APPLICATION TO THE RESIDENTIAL DESIGN AND COMPATIBILITY COMMISSION (RDCC)

GENERAL MODIFICATION WAIVER (#2)

STREET ADDRESS: 3210 Stevenson Avenue
LEGAL DESCRIPTION: Subdivision – Tarrytown No. 4
Lot(s) 103 Block Outlot Division
LAND STATUS DETERMINATION CASE NUMBER (if applicable)
I/We Kari Blachly on behalf of myself/ourselves as authorized agent for
Melissa Ann Jones affirm that on 4/5, 2013,
hereby apply for a hearing before the Residential Design and Compatibility Commission for modification Section 2.8.1. of up to 25% increase in one or more of the following:
Maximum Floor to area ratio .4 or Gross floor area 2300 sq ft. Maximum Linear feet of Gables protruding from setback plane Maximum Linear feet of Dormers protruding from the setback plane
Waive or modify the side wall articulation requirement of Section 2.7.
X Side Wall Length Articulation (Please describe request. Please be brief but thorough).
The side wall articulation waiver request is to be able to provide adequate room for the owners proposed pantry, and kitchen counter / cabinetry, and under counter garbage. The owner if this property is wheele bound and the required articulation in the 39' wall would severely imp

и овесинея 2012 A1.0

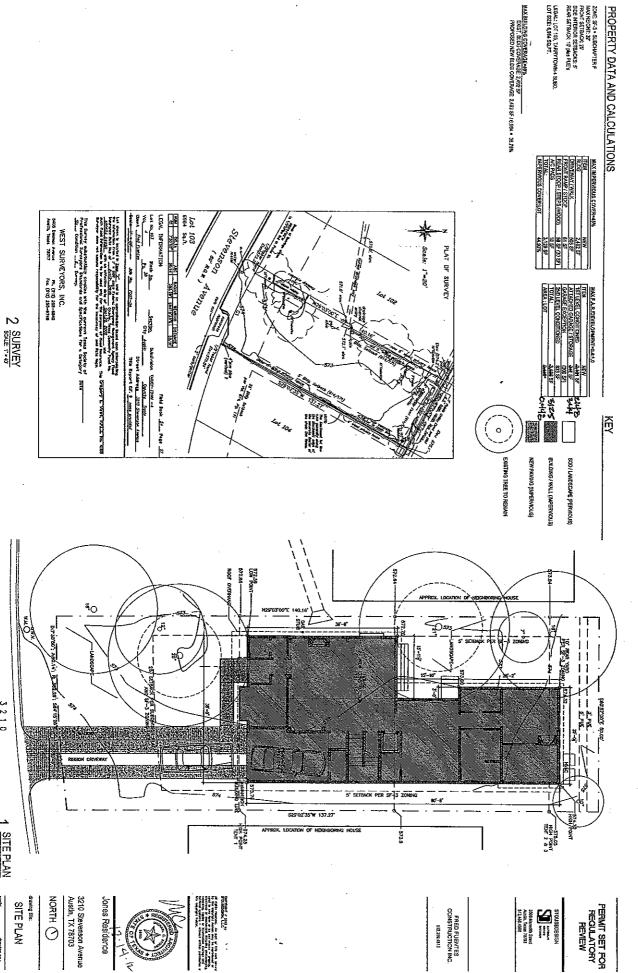
- 1. Please provide an Owner Letter of Authorization with the correct project address.
- 2. The building permit cannot be issued until the Tree Permit has been completed.
- As depicted on plan sheets and listed in the application, the stated FAR for the project is 0.448. This exceeds the allowable maximum of 0.4. Please modify the design.

- The application and east elevation indicates sidewall articulation is required. Please do so. Alternately, you may appeal to the RDCC as noted above. The RDCC may waive or modify the side wall articulation requirement.
- 5. The front plane of the McMansion build line begins at the southernmost point of the front ramp/stoop and metal rail, not at the window seat. Please correct.
- 6. Please provide average grade measurements adjacent to the building on site plan and elevations so building height may be determined/confirmed.
- 7. The driveway width must be a minimum of 12' at property line.

Additionally, the minimum concrete ribbon width is 3 feet with a 2 feet wide pervious strip in between. Please correct and update impervious cover calculations as necessary. Please provide separate calculations for the driveway, sidewalk, and front ramp/stoop.

8. A sidewalk along Stevenson Avenue is required. Please depict on plan sheets. If you request to pay a fee in lieu of actual sidewalk construction, please contact Amber Mitchell (974-3428) in the Development Assistance Center.

- Please label the drainage way and entry on site plan; please correct existing building coverage in Property Data table on sheet 1.
- 10. Please label elevator on both levels of the floor plan.
- 11. Additional review comments may be generated in response to your update.
